JOHN G. WILLIAMS LTD., ARCHITECT
ARCHITECTURAL CONTROL REVIEW
AND APPROVAL

Greenpark
project name
RUSSELL GARDENS PHASE 3
checked by
scale
1:250
date
SEP. 2020
drawing no.
1

lot/block no.
101
registered plan no.
62M-1266
project no.
19014
drawing no.
1

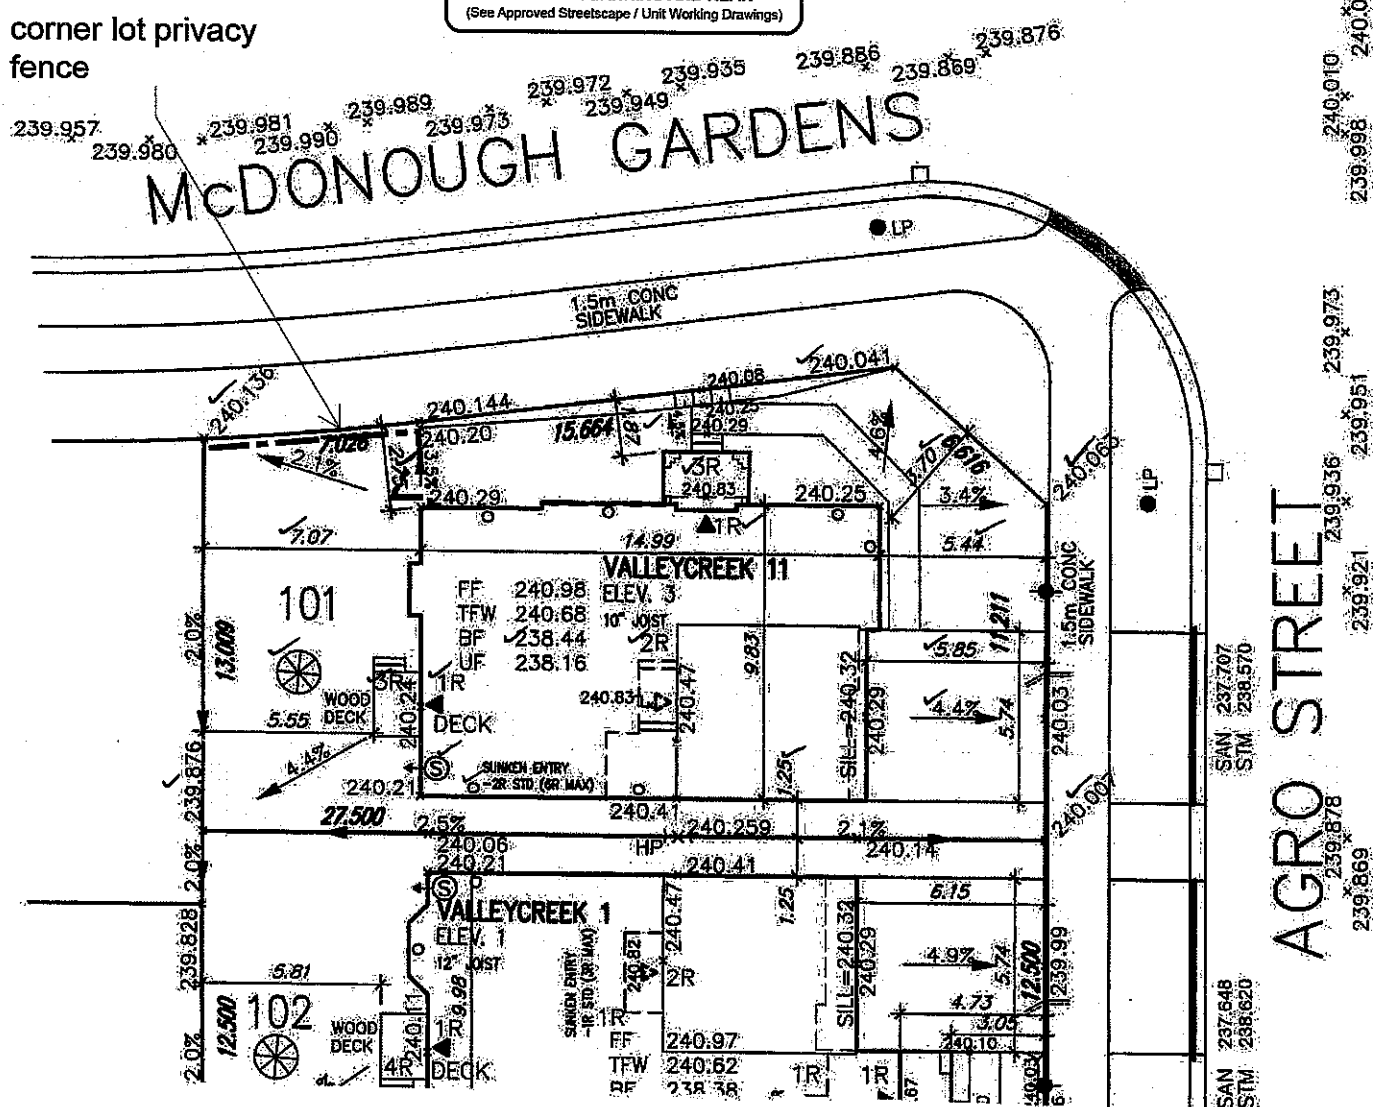
STEP SETBACK MIN 0.6m
TO PROPERTY LINE.

- CORNER LOT -
UPGRADE FLANKING AND REAR
(See Approved Streetscape / Unit Working Drawings)

corner lot privacy
fence
